### TRANSMITTAL SHEET FOR NOMAD SERVICE BULLETIN

SERVICE BULLETIN NO.: NMD-53-8

Fuselage, Enlarged Access Panel for Oleo Charging Valve in Pods

(Mod N547).

Installation of Cover Assembly Figure 1

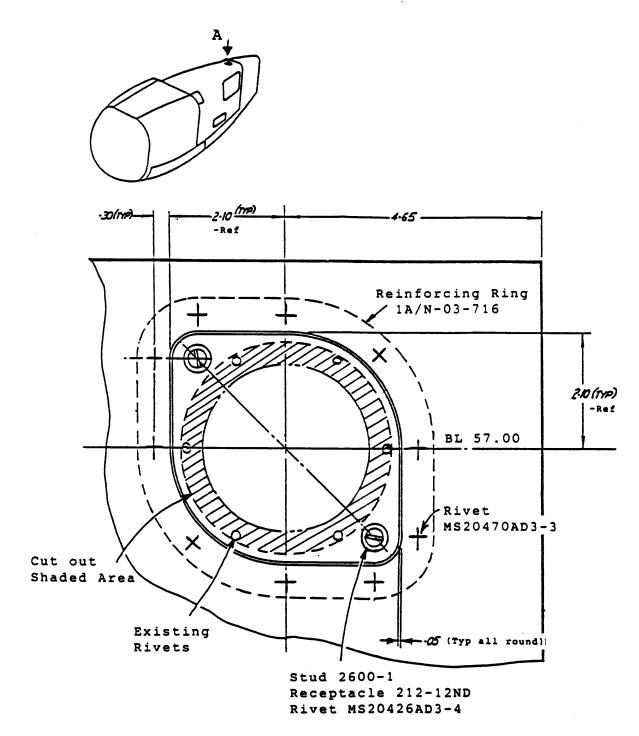
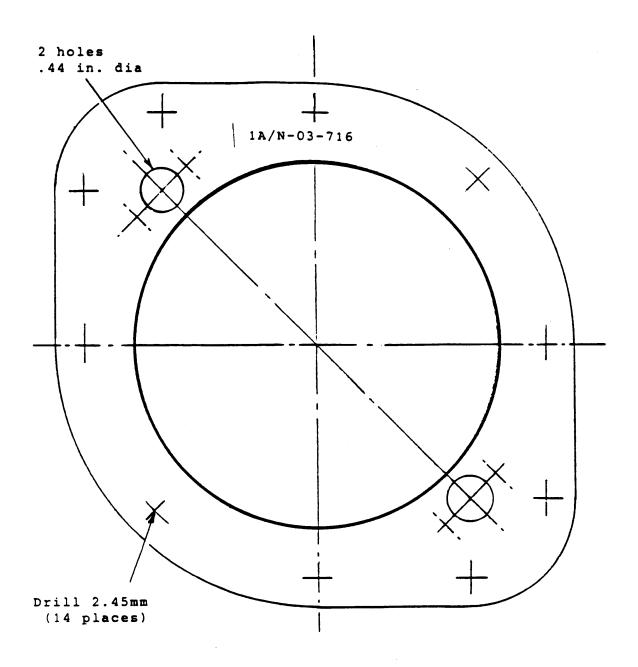
The existing access cover on the top rear of the pod is replaced by a larger cover.

- D. Position the re-inforcing ring and, using the re-inforcing ring as a template, drill out the holes for the rivets. Deburr holes and rivet re-inforcing ring in position using ten MS20470AD3-3 rivets. Repeat operation on opposite pod.
- E. Fit the cover plates and secure in position with 'Camloc' 2600-1 studs. Paint covers to match aircraft colour scheme.

Template for Reinforcing Ring Figure 2

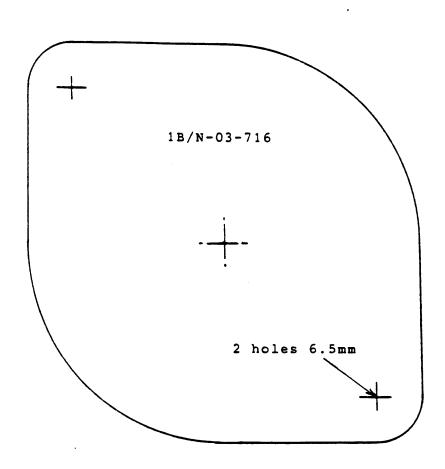
Material - .020",2020-T3 Alclad QQ-A-250/5
